**Design Review Board
Regular Meeting**

**Tuesday, October 19, 2021, 7:00 P.M.
AGENDA (REVISED)**

2. 1580 Lincoln Avenue (San Rafael Inn)

REPORT TO DESIGN REVIEW BOARD

Figure 2: Proposed Site Plan

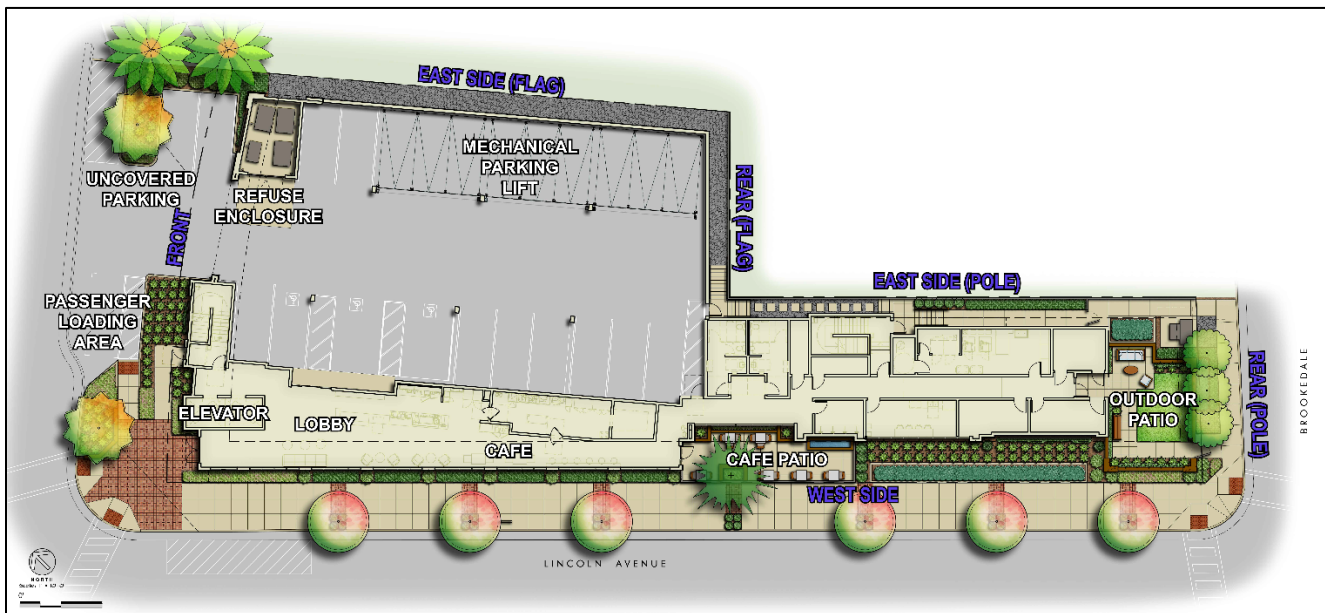
The project proposes to demolish the existing, approximately 930 square foot garden center building, outbuildings, and associated site improvements and construct a new, 46-room, four-story hotel with a 13,343 square foot building footprint and 44,485 square foot floor area. The project would also install 1,844 square feet of landscaping, 1,739 square feet of hardscape areas, and 842 square feet of paved surfaces including sidewalk, curb, and driveway areas. In addition, the project proposes improvements within the public right-of-way along Grand Avenue including 625 square feet of landscaping and approximately 2,000 square feet of paved surfaces to accommodate sidewalk, curbs, and the driveway (see Sheet A8 of Exhibit 1a for lot coverage diagram). Given the unique shape of the lot, there are six property lines from which the structure is measured to determine compliance with applicable setbacks including one front, two rear, two east side, and one west side. Setbacks from the rear and east side property lines are described as “flag” or “pole” to indicate the location on the lot, as shown in Figure 2. As proposed, the structure is located 2-feet 8 ¼-inches from the front property line, 5-feet 1 ⅝-inches from the rear (flag) property line, 22-feet from the rear (pole) property line, 5-feet from the east side (flag) property line, 4-feet from the east side (pole) property line, and 3-feet from the west side property line. The building has an overall height of 54-feet 9-inches as measured to the stair/elevator tower located at the southwest corner of the lot.
